Modification Bulletin

20-0033 - MB - EUR - YT - CAM0187 air intake damper and aftertreatment cover (DOT only)

Air intake damper and aftertreatment cover YT193 DOT

figure 1, noise damper on engine (old design)

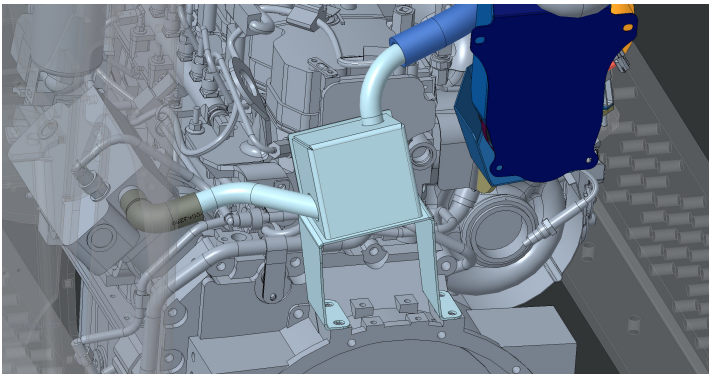
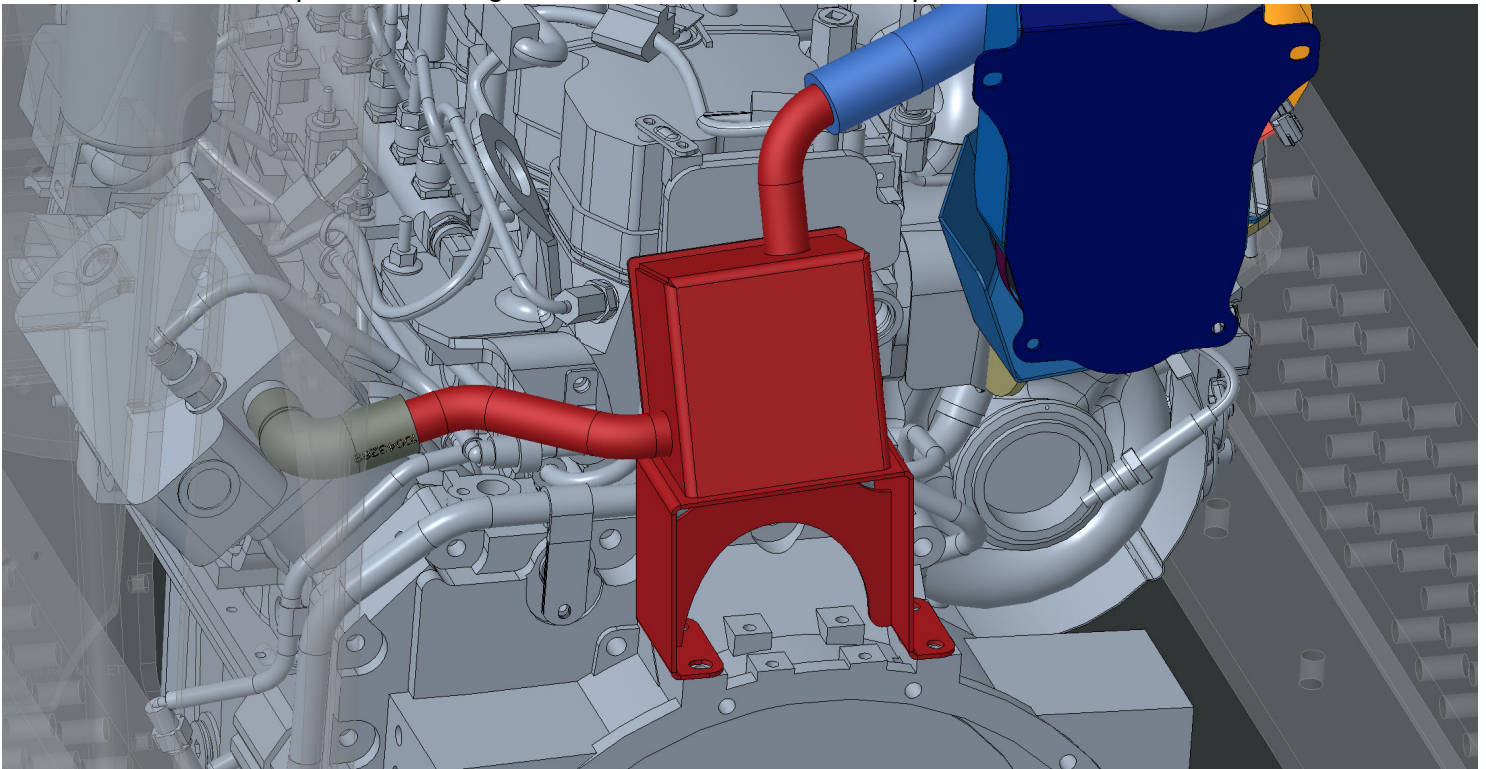
- **Aftertreatment System Cover:** The shape of the cover has been redesigned to prevent contact with the air inlet.
- **Air Intake Noise Damper:** The damper on the compressor air intake has been reinforced to better withstand vibrations and improve durability.

1. Park the vehicle in a safe place, apply park brake and switch engine off.
2. Tilt the cabin fully.
3. Remove the hoses that connect tot the air intake damper.
4. Reomove the bolts that connect the damper to engine housing.
5. Install new damper, re-use flange bolts M8x20, t29064192. Torque these bolts to 25Nm.

figure 3, damper t10043429 new design.

figure 4, intake hose t10112217

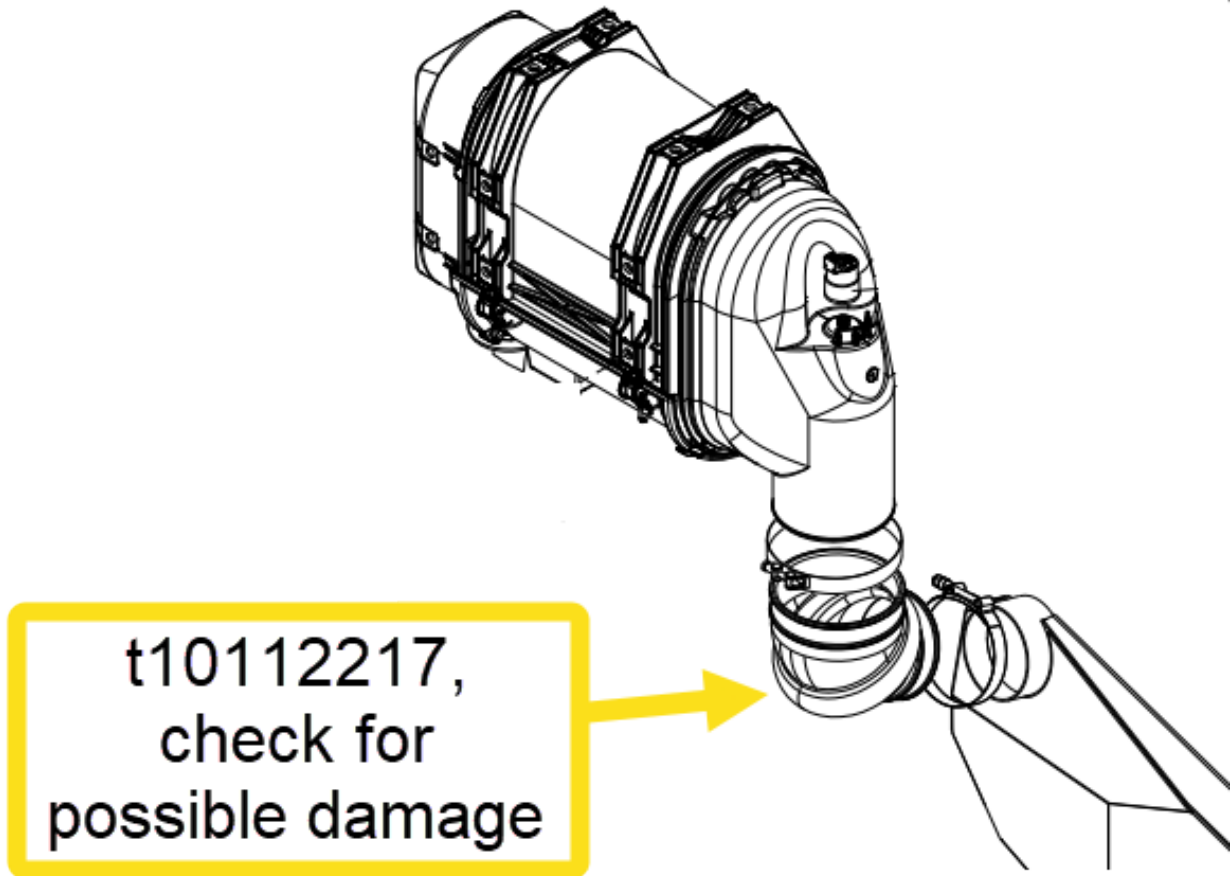
8. Remove the cover t24126568 from the exhaust/aftertreatment cover.
9. Check if the cover has been wearing on the air intake hose t10112217. Replace this intake hose when visibly worn due to contact with the cover. See figure 4.
